In the matter of Application by Hastings District Council and Napier City Council to
Hawke's Bay Regional Council for resource consents authorising
the operation of Area B at Ōmarunui Landfill (**consent application**)

Supplementary evidence by Anthony Gerard Bryce responding to s 92 request

Dated 14 October 2021

Figure 1: Stockpiles in Area B

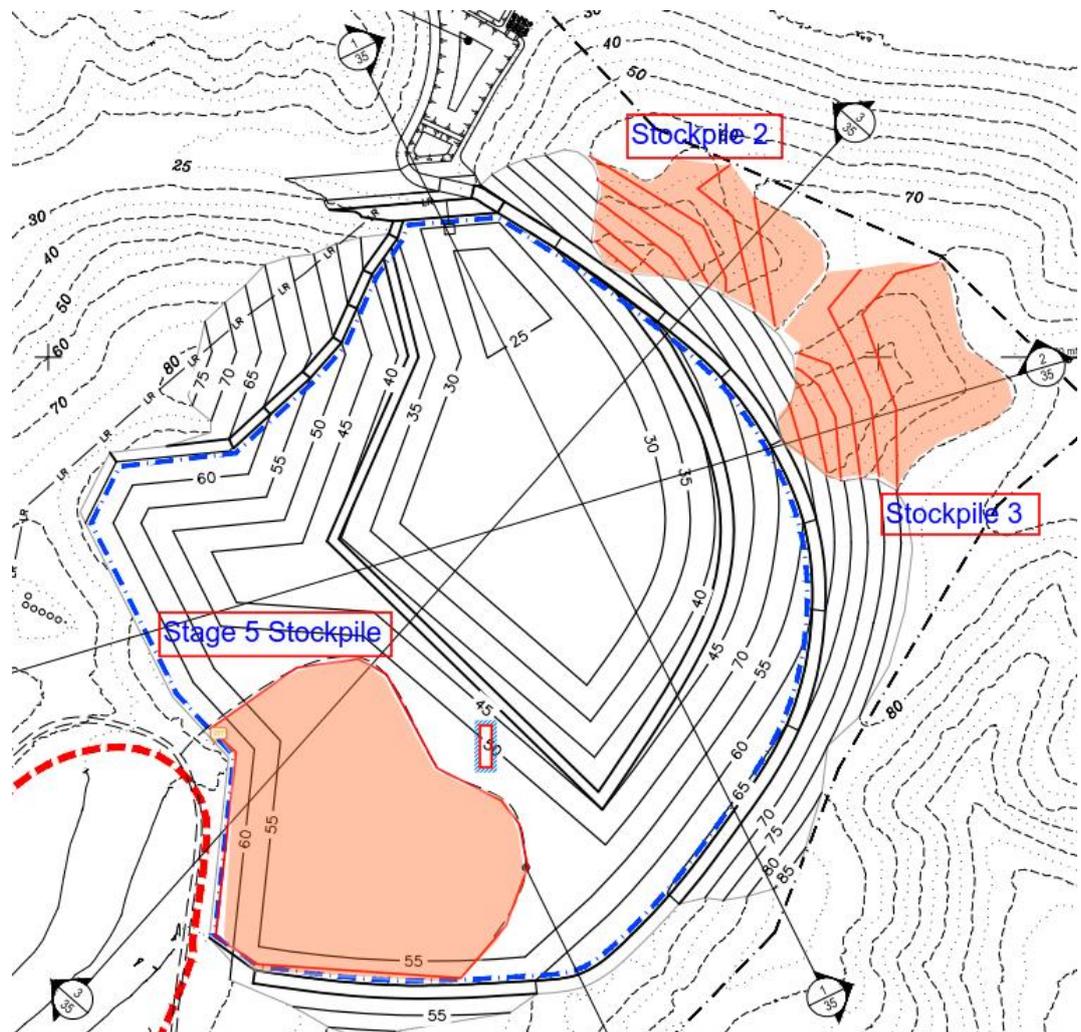
1. There are 3 proposed stockpiles as shown on dwg 1000-21. From my calcs for the area of these stockpiles they are going to need to be over 10 m high to provide the required volume if all of the 600,000 to 800,000 m³ excavated goes to these nominated stockpile areas. There is no discussion about the stockpiles that I can see re stability, visual effects, duration, size and interim and final landform and cover. There is also very little discussion of erosion and sediment control requirements except some text in the AEE and the geotech report that an erosion and sediment control plan shall be prepared. There is nothing in the draft conditions or in the O&M plan requiring an ESCP or other detailed discussion of stockpiles.

- expected maximum volume and maximum height of various stockpiles, description of measures that will be used to ensure stability (e.g. stockpile management plan?)
- duration and area of stockpiles that will be operating in a bare condition i.e. being used as source of construction fill or cover material for the construction of the Area B landfilling or other purposes
- visual effect of the stockpiles

8. The location and layout of the stockpiles is shown on Figures 1 and 2 below. Stockpile 1 is located in the valley to the north of Area C. The other stockpiles are within the Area B valley.

9. The volume of each of these stockpiles is described below:
 - (a) Stockpile 1: Up to 400,000 m³ as depicted in Figure 2, but the site has capacity for a greater volume. The stockpile covers an area of approximately 35,000 m².
 - (b) Stockpiles 2 and 3 have a combined maximum capacity of 170,000 m³ (65,000 m³ and 105,000 m³ respectively). However, the actual volume may be less than this (100,000 to 120,000 m³) once the practicalities of operating these stockpiles is considered.
 - (c) Stage 5 Stockpile: Approximately 200,000 m³ as described above, covering an area of approximately 27,000 m².

10. The height of the stockpiles is variable. The heights are generally as follows:
 - (a) Stockpile 1: Toe at approx. 30 mRL and the top of the front face at approximately 60 mRL, rising to a peak of 70 mRL.
 - (b) Stockpile 2: Top level at approximately 70 mRL rising from approximately 40 mRL at the landfill perimeter road.
 - (c) Stockpile 3: Top level at approximately 80 mRL rising from approximately 50 mRL at the landfill perimeter road.

- 13. Stockpiles 2 and 3, within smaller gully systems in Area B, will be formed by stripping topsoil, keying into the existing ground, largely into competent sandstone and limestone rock, and placing fill in layers. A spring has previously been observed on the footprint of Stockpile 3 and this would need to be drained (subsoil drains) to the landfill perimeter surface drain at the toe of the stockpile.

18. The top level of each of Stockpiles 2 and 3 is no higher than the level of the ridge-line adjacent to the stockpiles. There is no direct line of sight to these stockpiles from off-site either during filling or after filling.
19. The top level shown for Stockpile 1 is at 70 mRL with the adjacent ridges being up to 90 mRL. Again, there is no direct line of site to this stockpile from off site.
20. The Stage 5 stockpile is on the landfill footprint and its height is less than the proposed waste height.
